University of Nebraska-Kearney
UNK West Campus Utility Corridor Expansion

ADDENDUM #1 SUMMARY

June 16, 2014

Attachment No. M1.2a
to Addendum No. 1
Dated: June 16, 2014

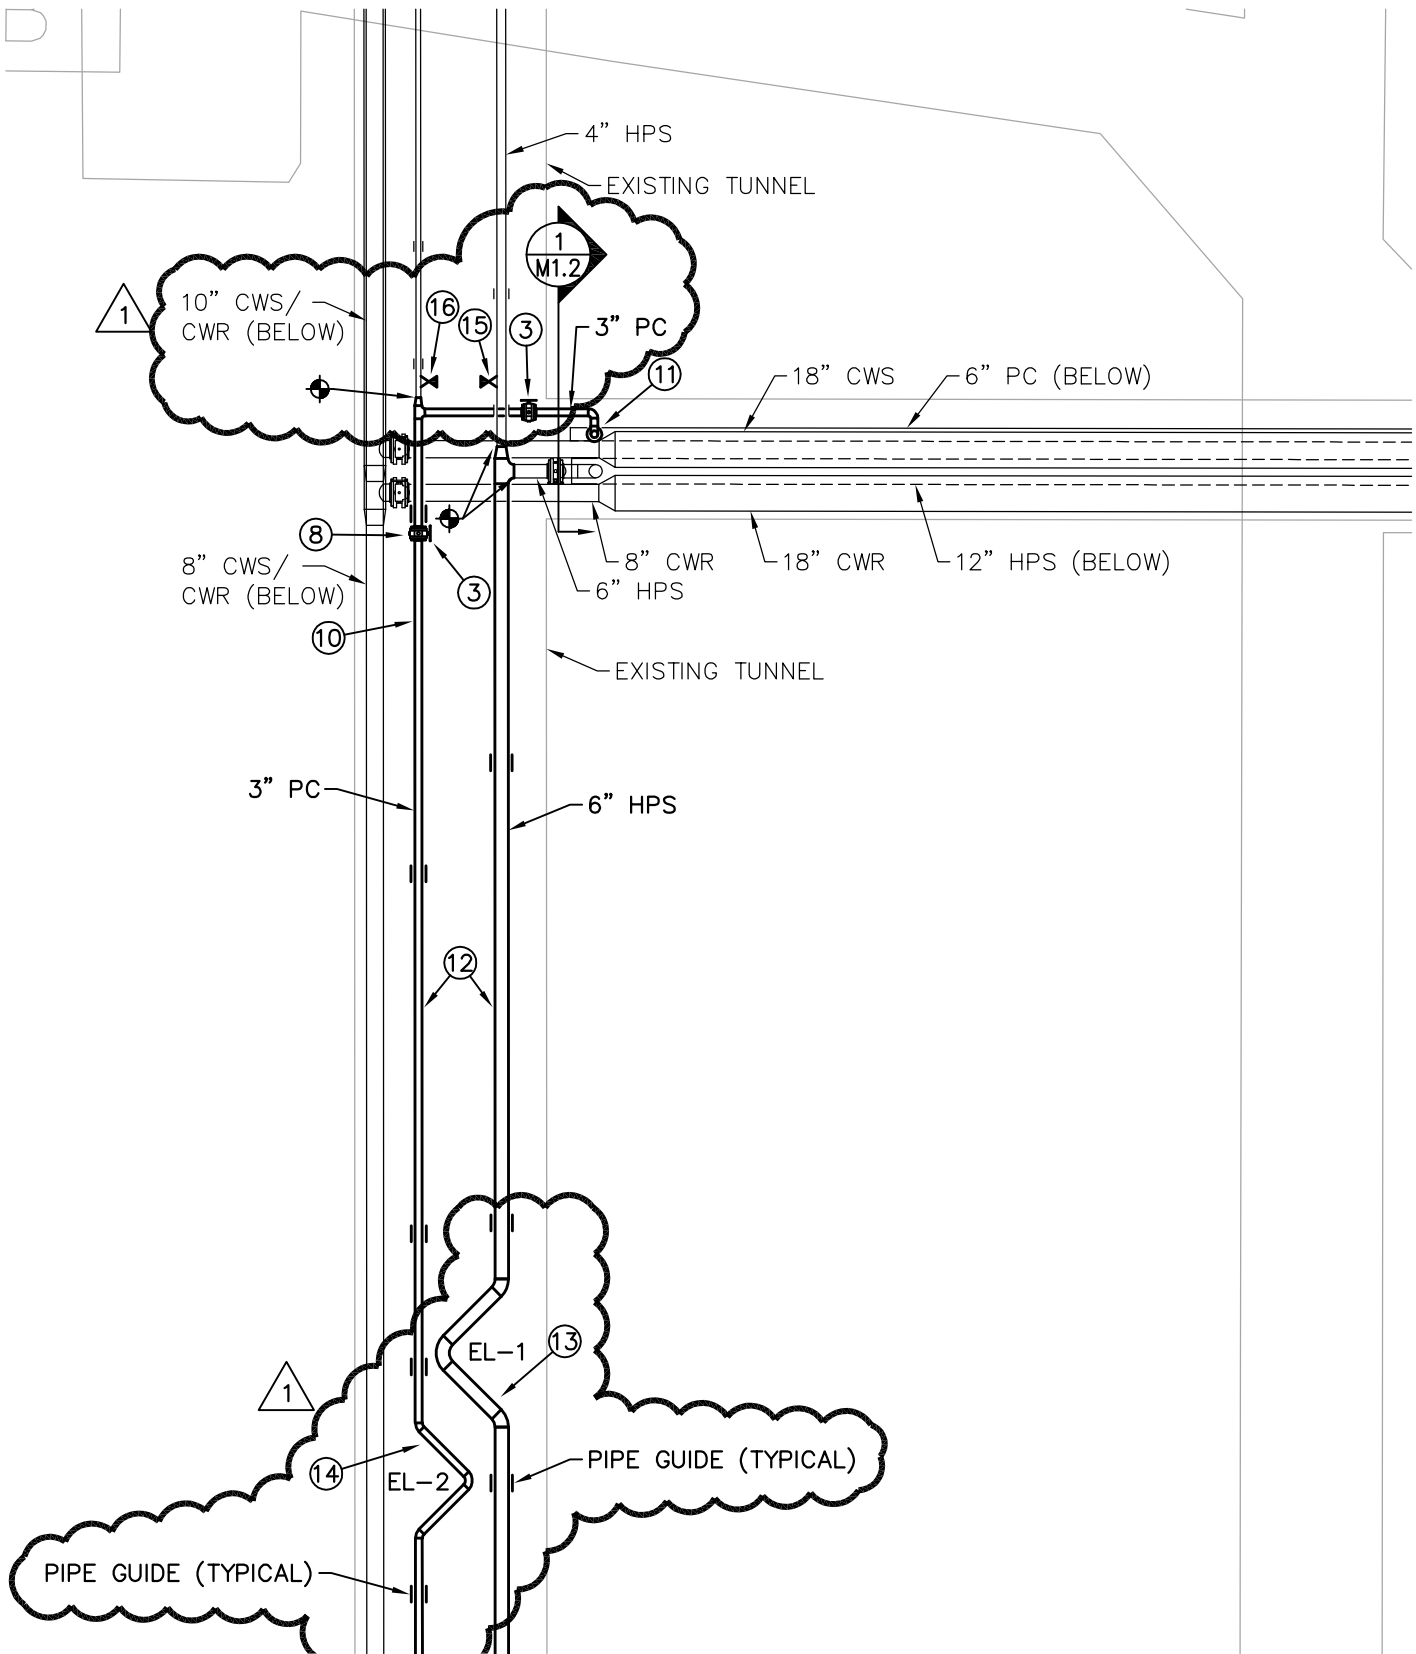
- A. Add pipe anchoring to the existing 4” steam and 2” condensate lines as shown on attached Construction Clarification M1.2a, dated 6/16/14. Anchor pipes as shown on the attached Construction Clarification M3.1a.

- E. Add the following Keynote 15: “Anchor the existing 4” HPS pipe in the approximate location shown. Provide anchoring from the ceiling of the existing tunnel capable of resisting 6300 lbs. of force.”

- F. Add the following Keynote 16: “Anchor the existing 2” PC pipe in the approximate location shown. Provide anchoring from the ceiling of the existing tunnel capable of resisting 2500 lbs. of force.”

Attachment No. M1.2b
to Addendum No. 1
Dated: June 16, 2014

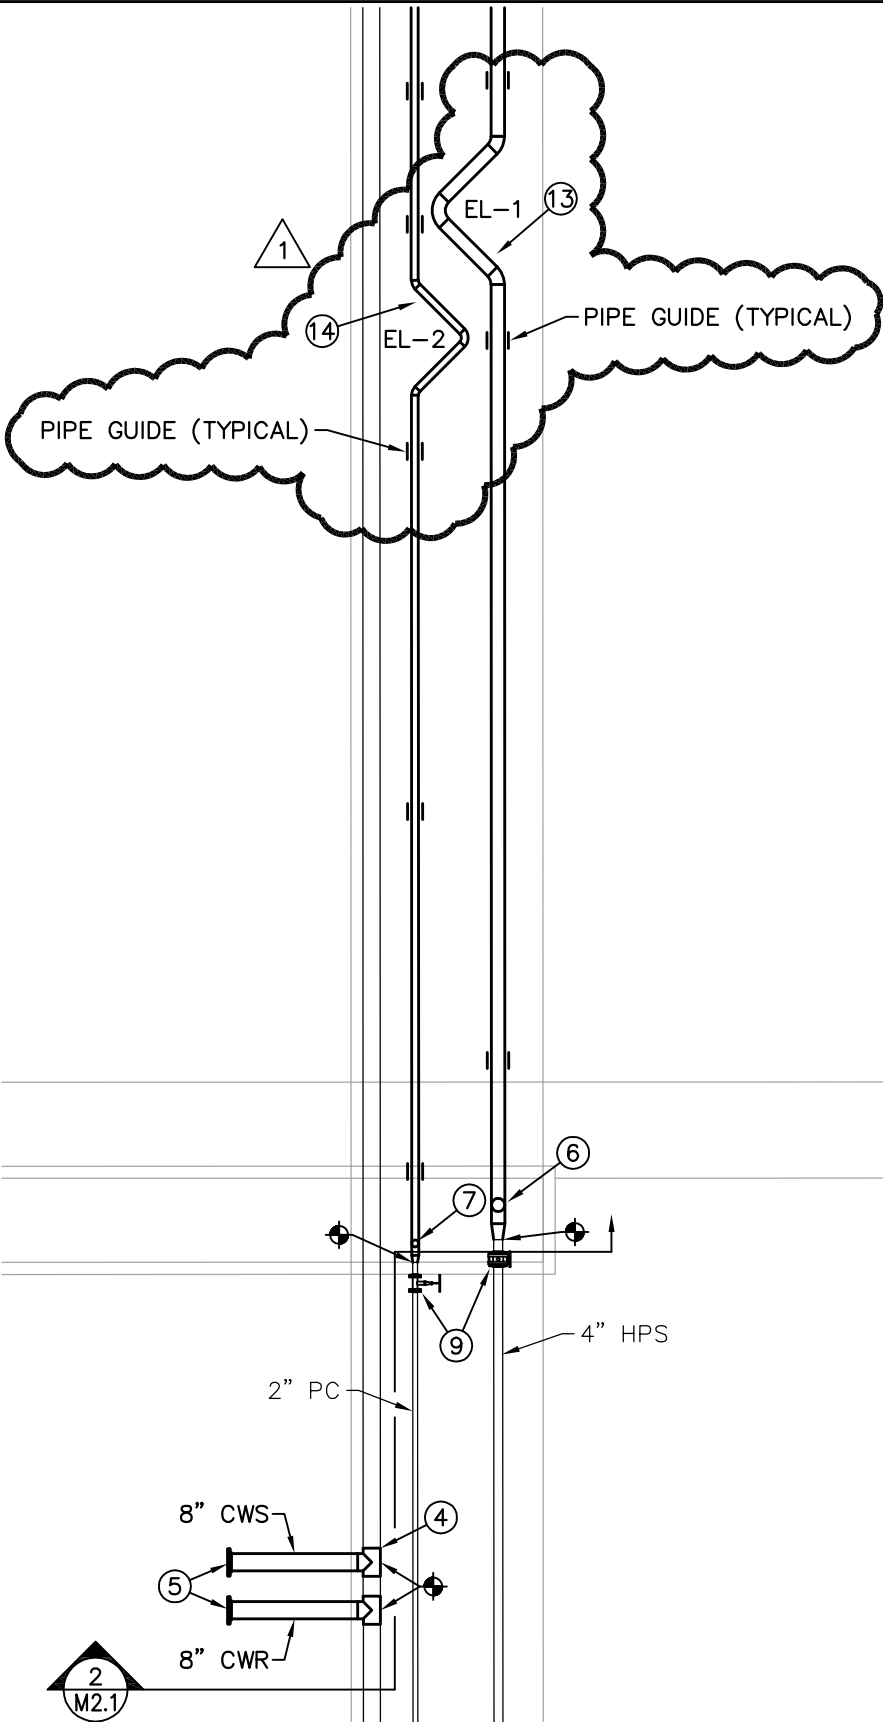
- B. Add pipe anchoring to the new pipe tees exiting the tunnel, and add expansion loops as shown on attached Construction Clarification M1.2b, dated 6/16/14. Anchor pipes as shown on the attached Construction Clarification M3.1a.

- C. Add the following Keynote 13: “Install Expansion Loop EL-1 in new 6” HPS piping. Provide pipe guides within 36” of expansion loop connections. Support the 90 degree elbow from the ceiling according to manufacturer’s recommendations to provide a horizontal installation. Provide 3” pipe insulation on expansion loop.”

- D. Add the following Keynote 14: “Install Expansion Loop EL-2 in new 3” PC piping. Provide pipe guides within 36” of expansion loop connections. Support the 90 degree elbow from the ceiling according to manufacturer’s recommendations to provide a horizontal installation. Provide 2” insulation on expansion loop.”

- G. Delete Keynote 6 and replace with the following: “Extend 6” HPS up through existing tunnel ceiling into new trench. Refer to sheet M1.3 for continuation. Anchor the pipe tee to the existing tunnel ceiling to resist a force of 280 lbs.”

- H. Delete Keynote 7 and replace with the following: “Extend 3” PC up through existing tunnel ceiling into new trench. Refer to sheet M1.3 for continuation. Anchor the pipe tee to the existing tunnel ceiling to resist a force of 115 lbs.”

Attachment No. C6.1a
to Addendum No. 1
June 16, 2014

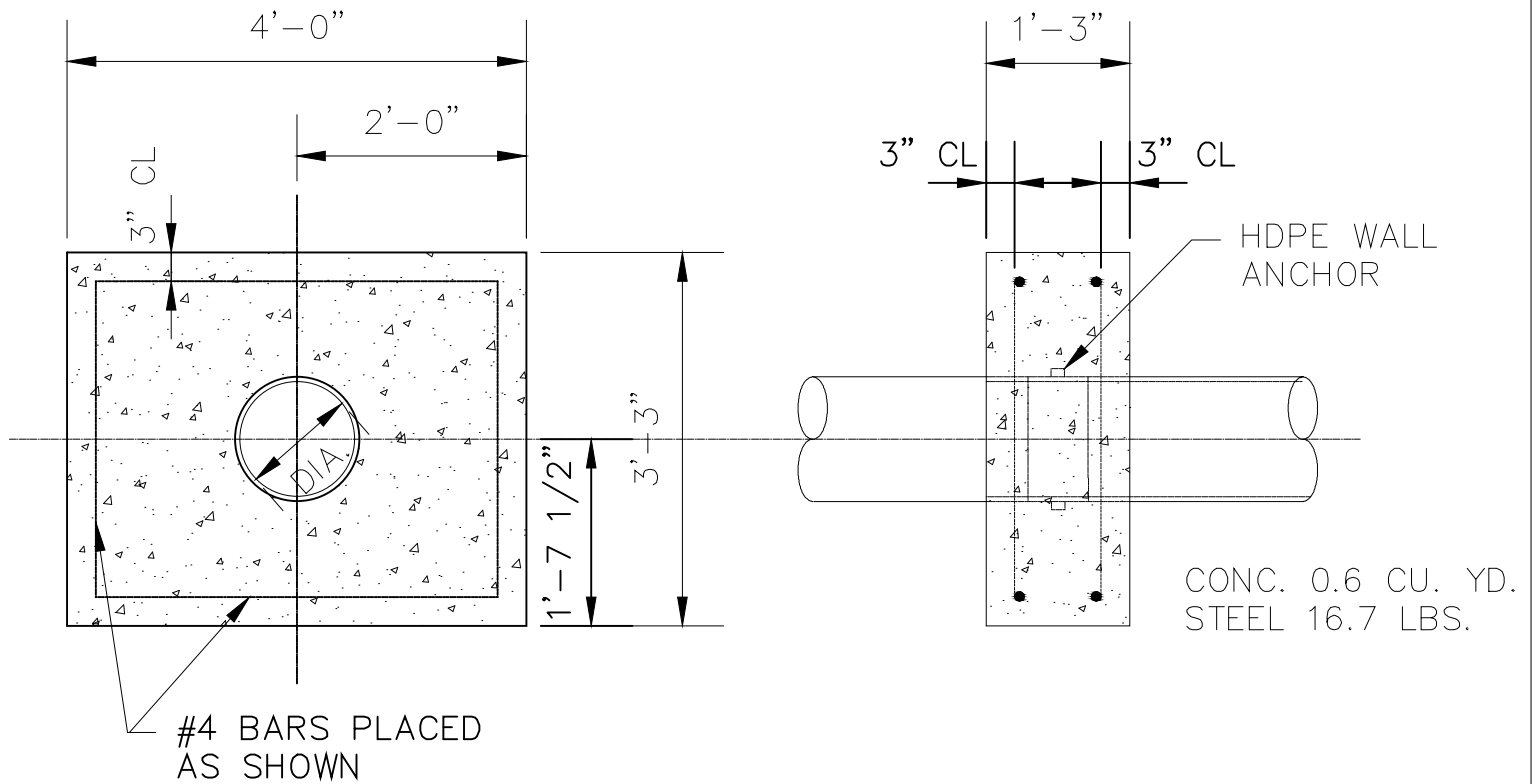
REFER to Chilled Water Supply & Return Plan, Sheet C6.1: Concrete thrust collars shall be added to chilled water supply and return lines at Sta. 0+10.00 and Sta. 8+25.00. Thrust collars shall be installed as shown on the attached detail C6.1a.
